Addendum #1

Date	Owner Property Number	Owner Building Number	BHDA Project Number
Fri, 21 Apr 2017	510-1409	1	1621

Project Designation	Project Address
Lakeridge 1, 4, 7 Remodel Orem UT Lakeridge Stake	158 East 1100 South Orem, Utah 84058

ENLARGED DEMOLITION PLANS AND ENLARGED PLANS

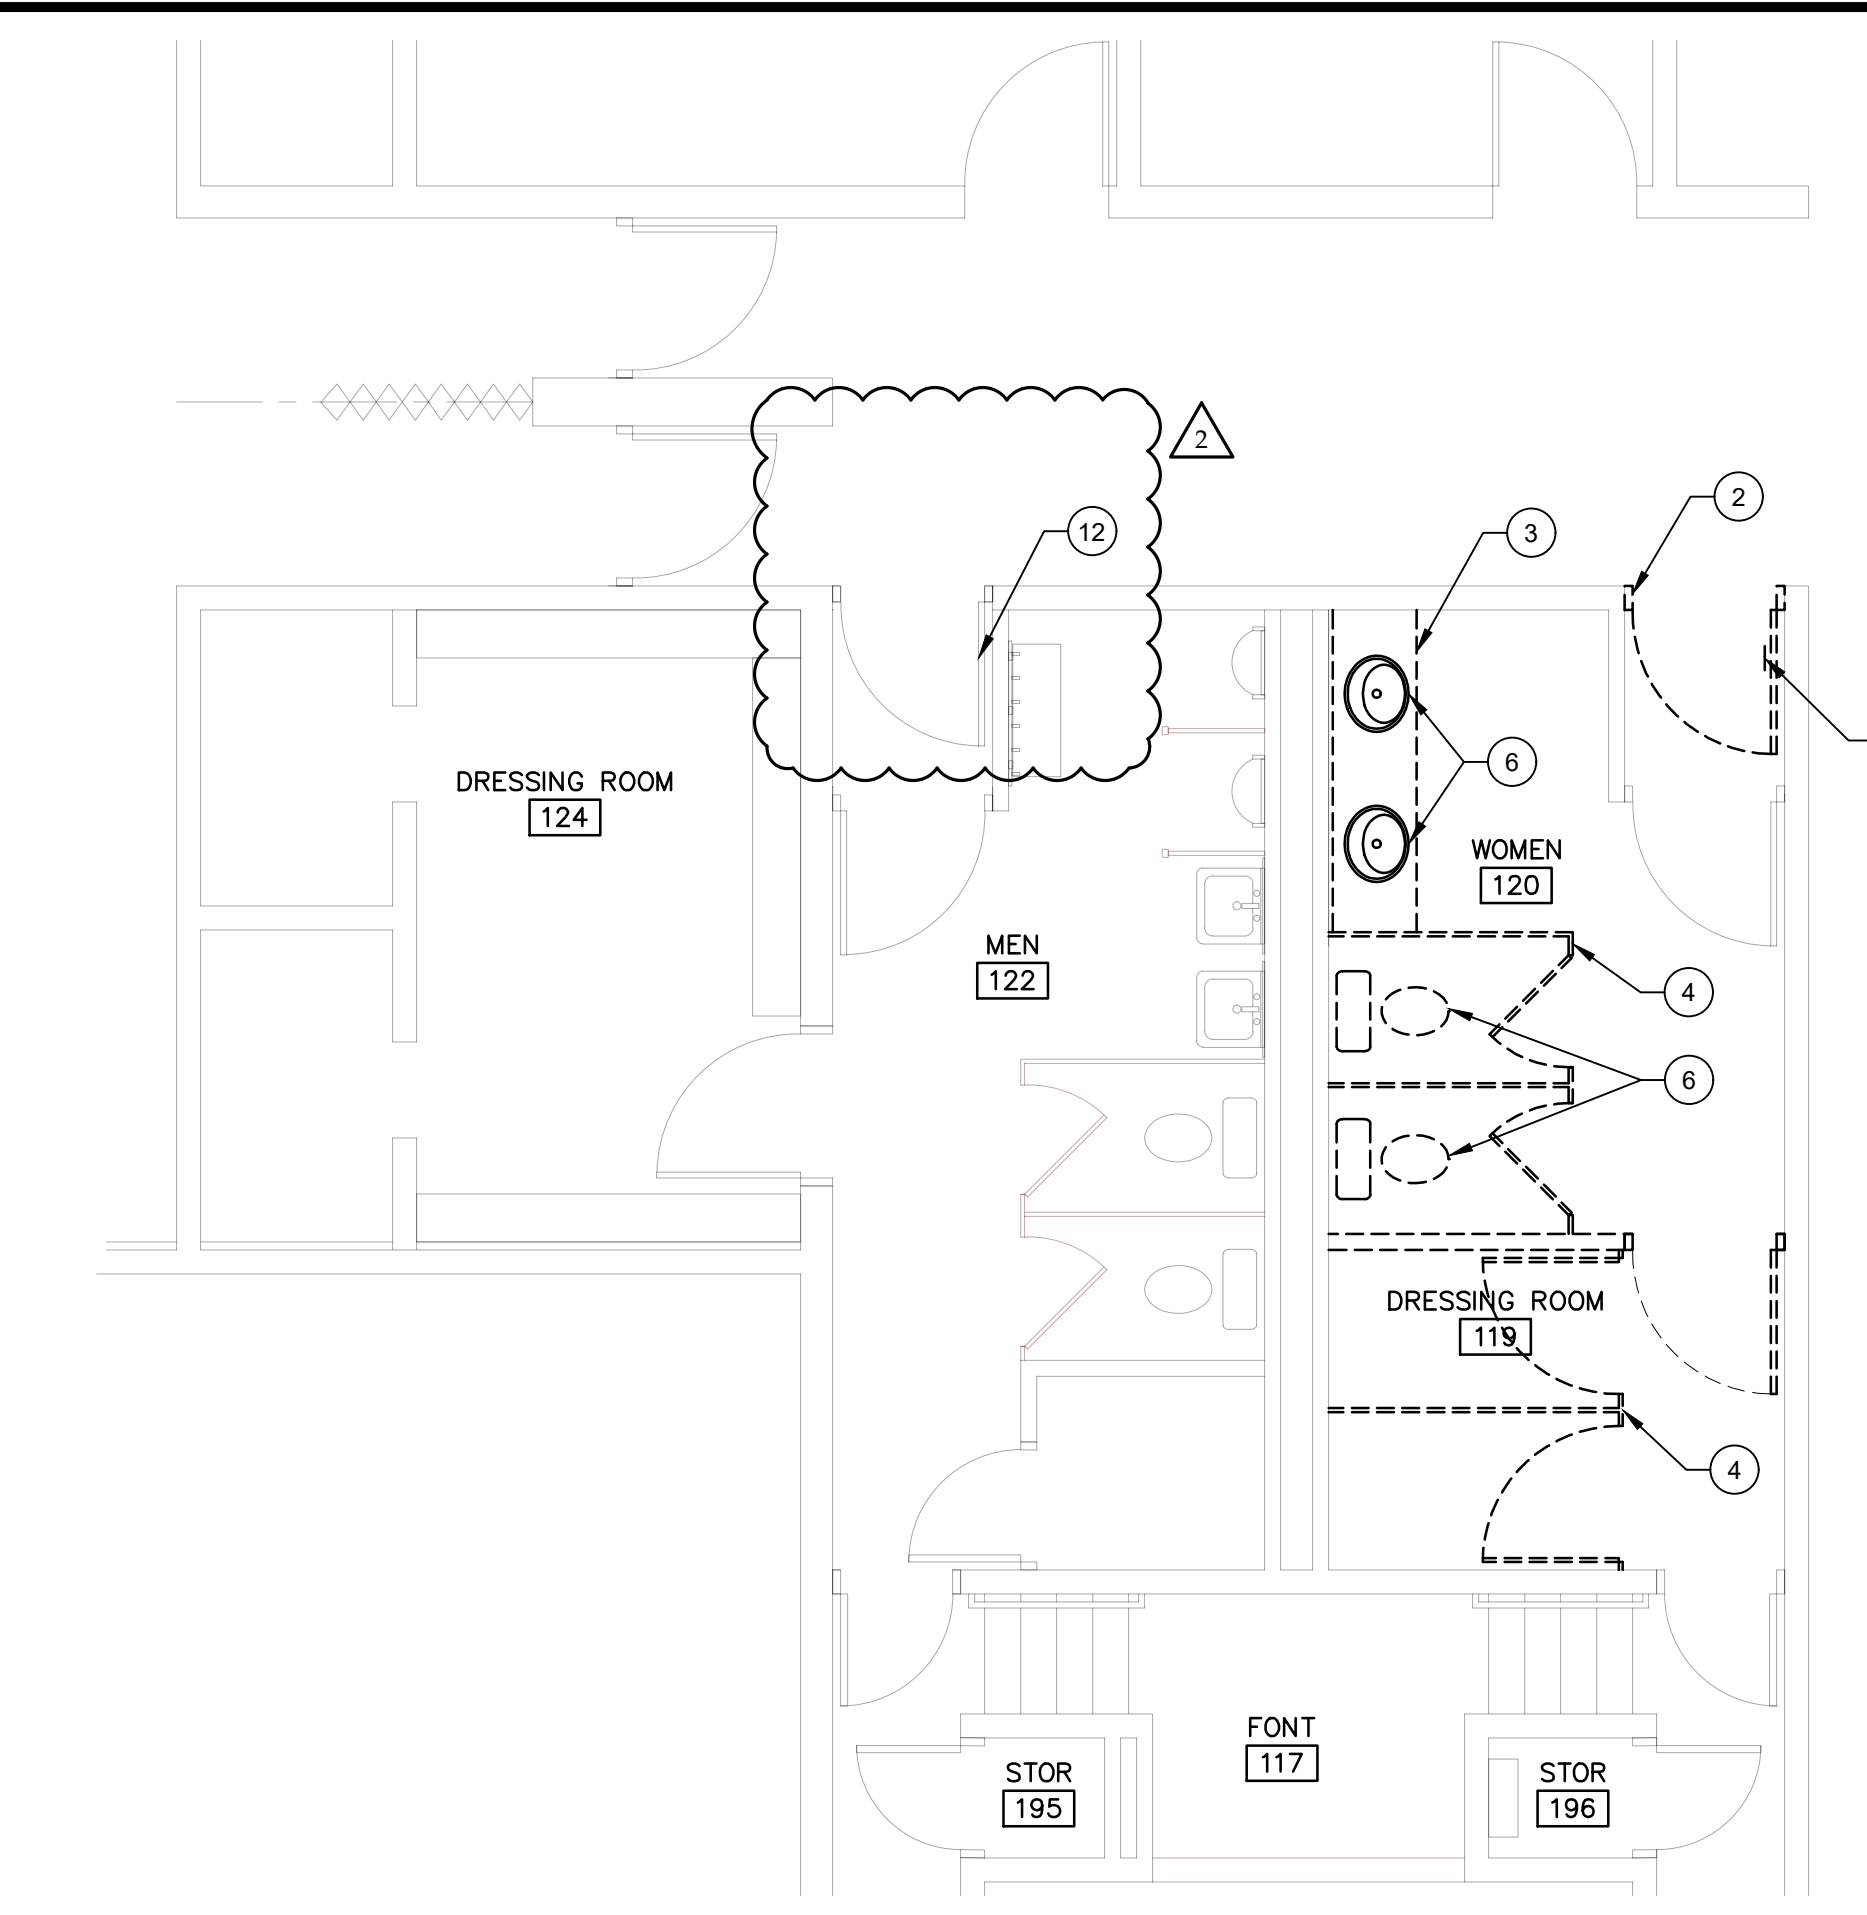
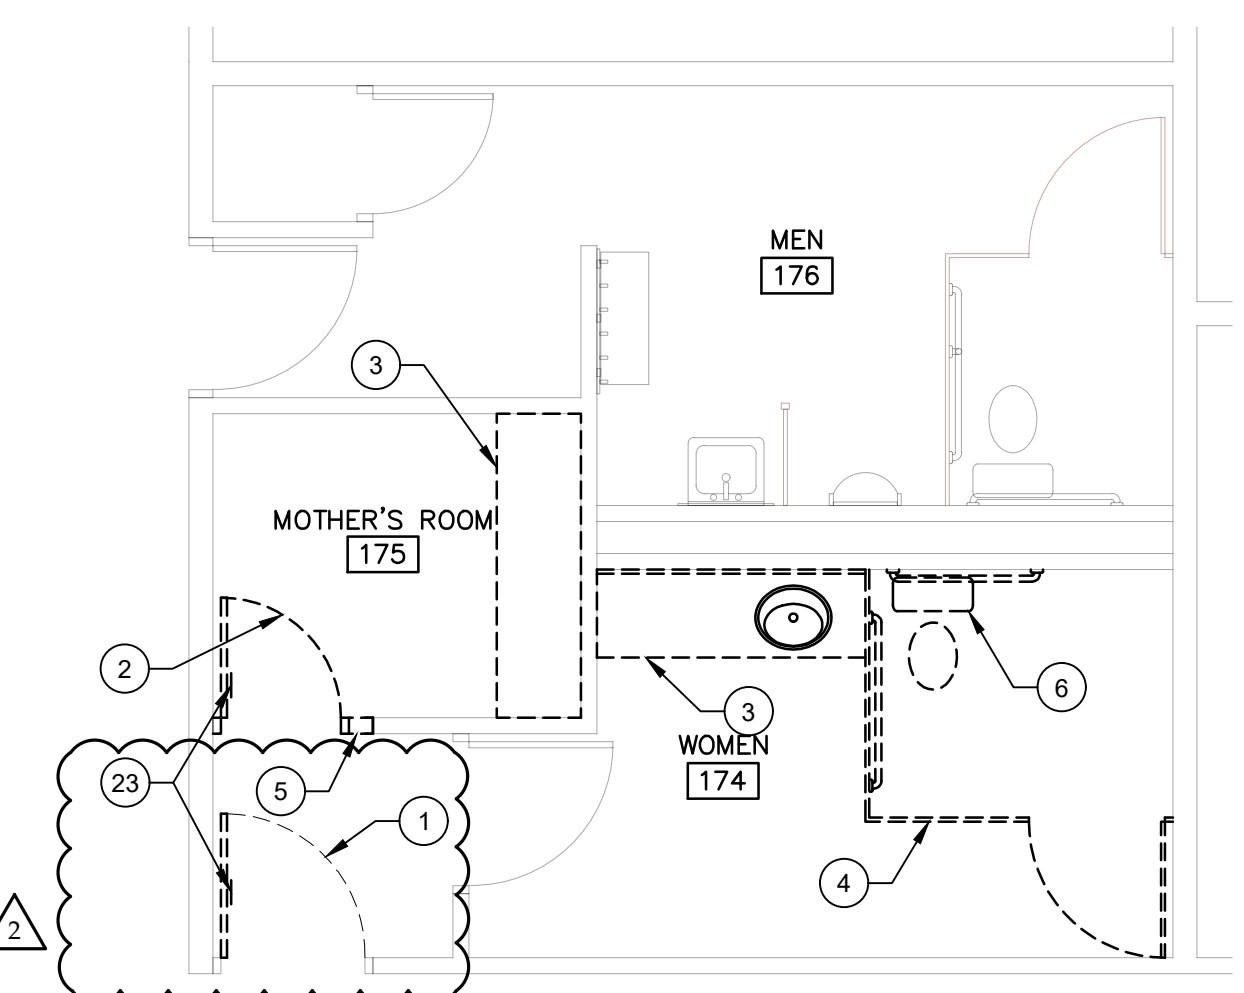
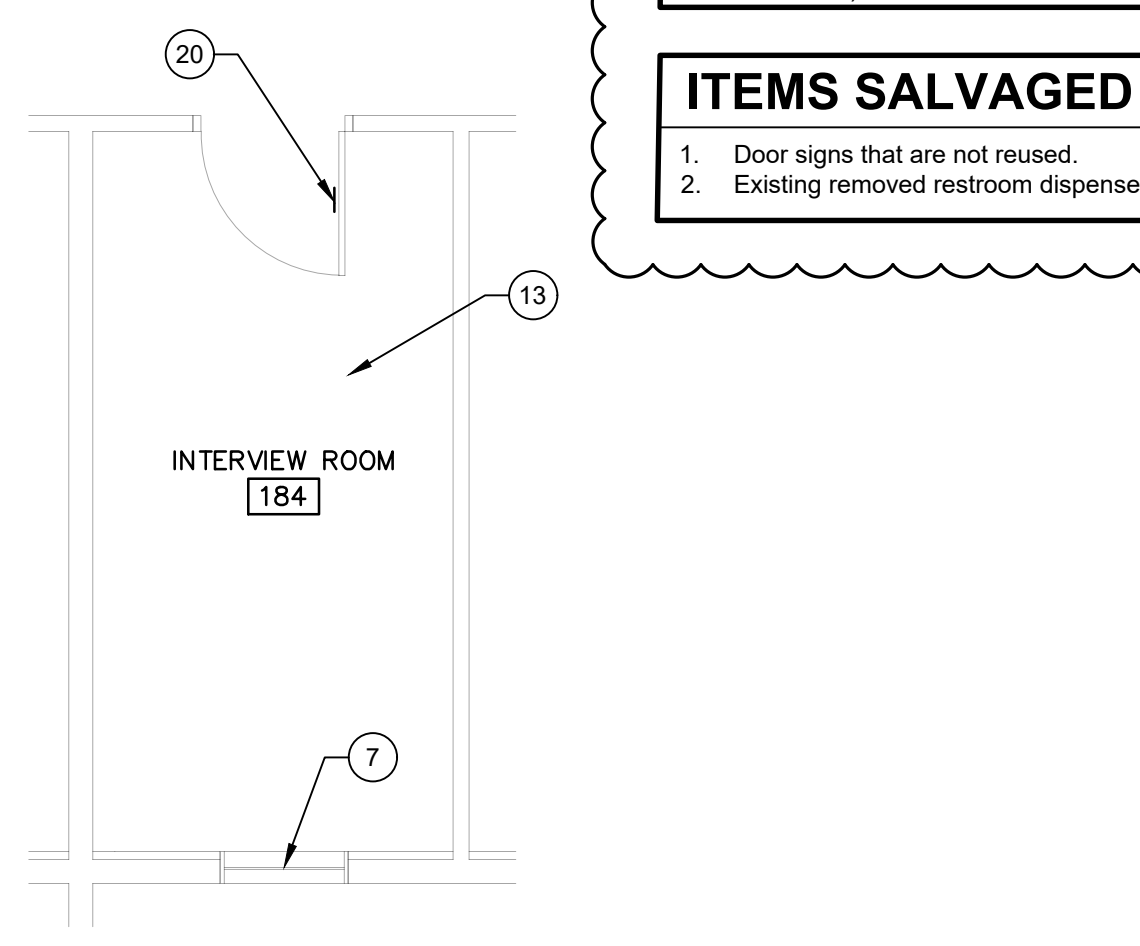
4.01. Sheet A101 Enlarged Demolition Plans and Enlarged Plans

A. Replace this sheet with the attached revised Sheet A101.
1. Modified notes about doors and door frames.
2. Clarified notes about work performed by the Owner and items salvaged to the Owner.
